# UNITED STATES PATENT AND TRADEMARK OFFICE

APPLICATION NO.	FILING DATE	FIRST NAMED INVENTOR	ATTORNEY DOCKET NO.	CONFIRMATION NO.
10/505,172	08/31/2004	Kenichi Nakatsu	P25834	6690

# Office Action Summary

## DETAILED ACTION

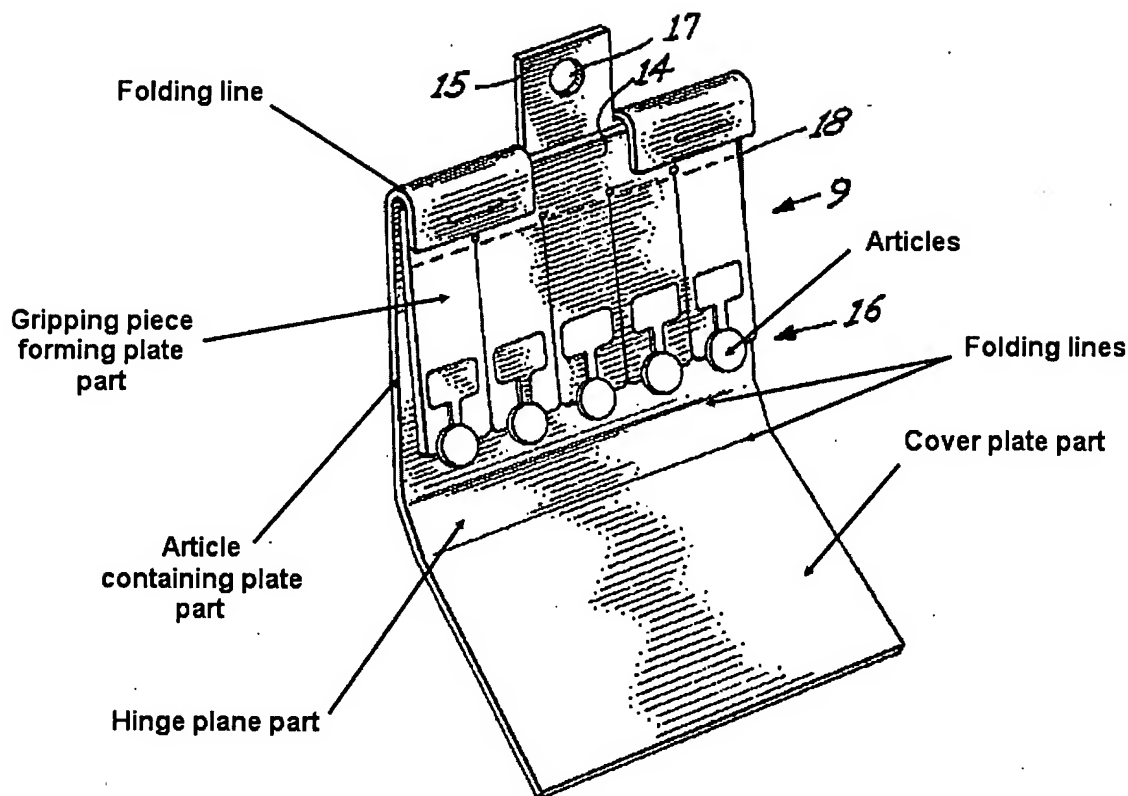
4. Claims 1-7, 9, 10, 13, 14, 16-20, 22, 23, 26 and 27 are rejected under 35 U.S.C. 103(a) as being unpatentable over Cerny et al. (US 4,860,890) in view of Malpass (US 4,693,371). Cerny et al. discloses an article packaging body being formed from a sheet of hard material comprising an article containing plate part (See Figure below) containing articles; a cover plate part (See Figure below) being connected with the article containing plate part; and a gripping piece forming plate part (See Figure below) being formed by extending from the article containing plate part via a folding line, wherein a plurality of gripping pieces is formed in the gripping piece forming plate part so as to be separable individually and to hold an article at the tip end of each of the gripping pieces, the gripping piece forming plate part is folded onto the article containing plate part, and the cover plate part is openably closed such that the gripping piece forming plate part is sandwiched between the cover plate part and the article containing plate part. Cerny et al. discloses the claimed invention except for the recesses.

Regarding claims 6 and 19, the modified device of Cerny et al. discloses the article containing plate part is connected with the cover plate part via a hinge plane part and folded to the side of the cover plate part along folding lines of said hinge plane part (See Figure above).

Regarding claims 7 and 20, the modified device of Cerny et al. discloses the hinge plane part is formed into a required width, by being connected with the article containing plate part by a folding line and with the cover plate part by a folding line.
